OICA position

Magnification Factor

OICA position

Point Light Sources

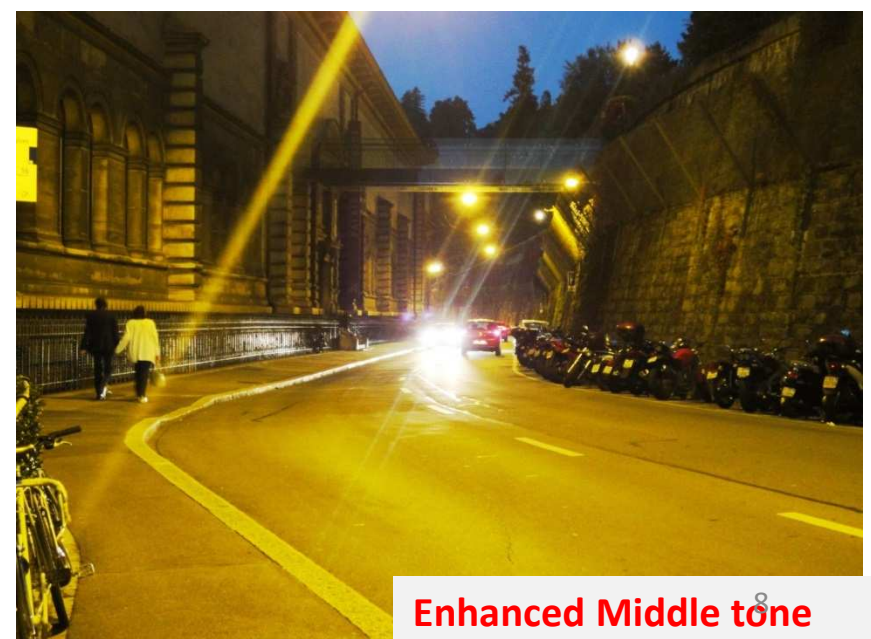
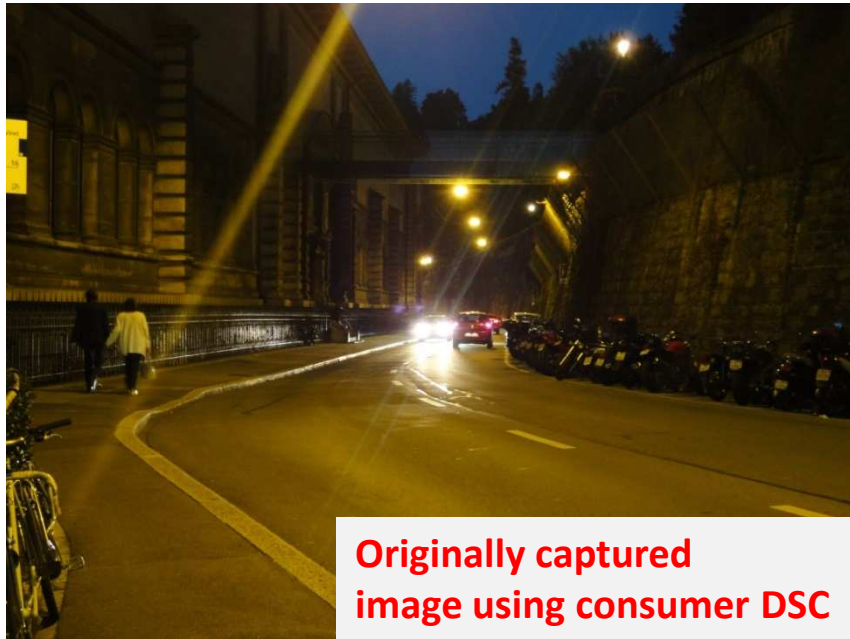
The following slide shows some image examples resulting of camera adjustment to satisfy strict PLSDF requirement, which is presently proposed for adoption within UN Regulation 46 as a requirement for CMS.

If strict requirement is imposed on PLSDF value, the CMS will have to adjust the operation of the system to show images like in the example shown at upper right image. **The driver loses a large amount of safety relevant visual information which is essential in the scene interpretation and decision making, by doing so.** (example of an urban scenario in Tokyo).

As replacing a potential safety issue with other potential safety issues being « carved » into regulation does not seem appropriate , OICA position is to **remove any requirement from the regulation about PLS** and let the manufacturer be responsible for the system performance.

But if strict high requirement on Point Light Source is a must for specific driving scenario, then OICA suggests that the CMS could be **adjustable** and have a manual or automatic operation mode where CMS satisfies the above strict high requirement on Point Light Source:

“CMS shall be adjustable whether manually or automatically, such that an operation mode is reserved to satisfy the $PLSDF \geq [2,5]$, according to test method and condition as described in Annex 12, paragraph XX [to be created].”

Grey Scale Rendering

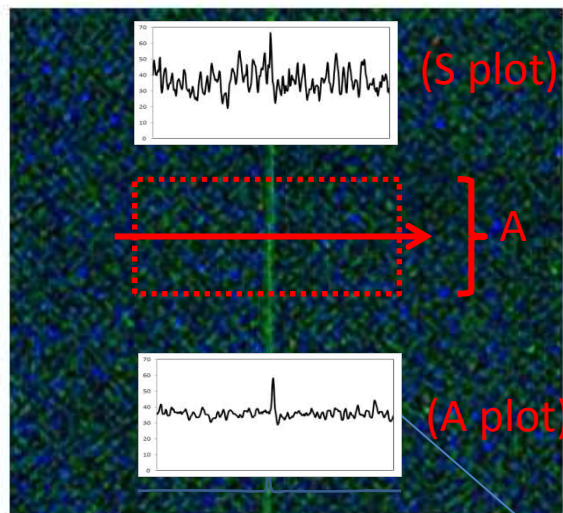
The grey scale rendering is introduced as test to verify that enough tonal steps are secured for displaying the field of vision through the CMS.

It is a common practice to improve the perceptivity of the content of image by controlling the input and output response, adjusting the contrast of the image to the viewer, and thus fastening the physiological process of perception.

On the other hand, an excess of contrast enhancement resulting in loss of minimum tonal representation to the output image may deteriorate this physiological process of perception.

It is therefore necessary to limit contrast to keep a minimum tonal step on the displayed image.

The devices for indirect vision shall be capable to represent enough tonal steps to secure a smooth tonal image of the field of vision on the monitor. The CMS monitor shall be able to represent at least **12 distinguishable steps of a grey scale chart** on the monitor display.

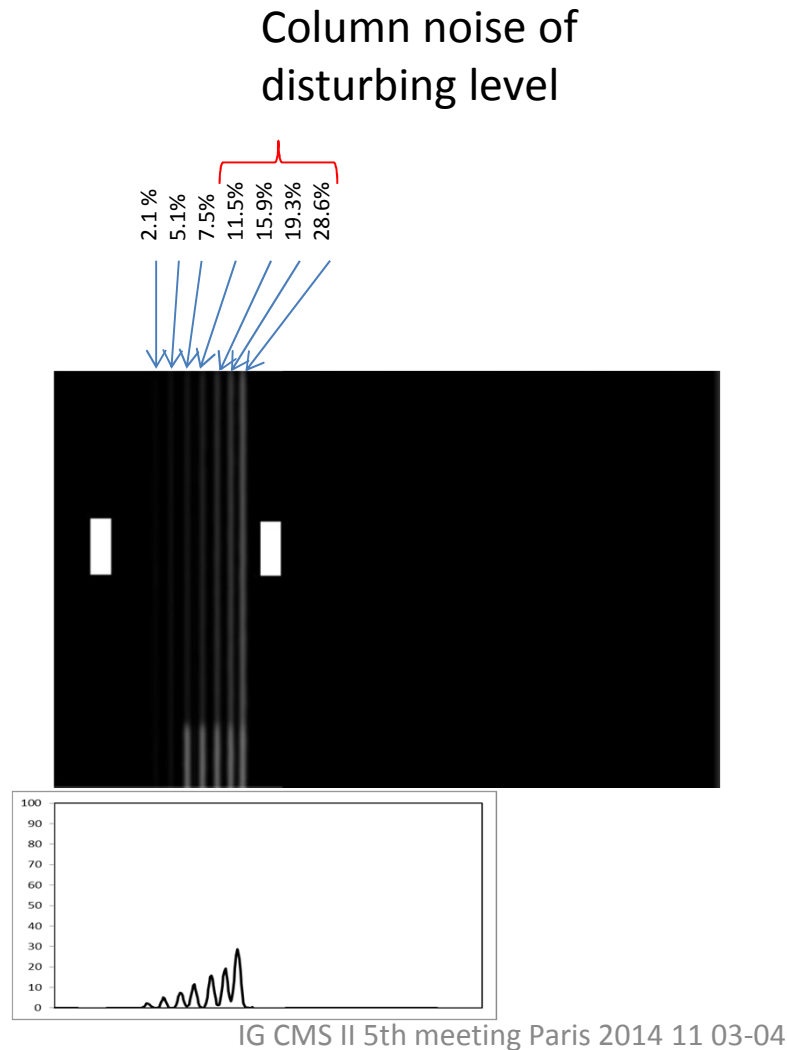
Artificially generated image to see the impression of what a vertical bright line would look like. Actual image on a working CMS may look difference due to further random noise and Dark pedestal level.
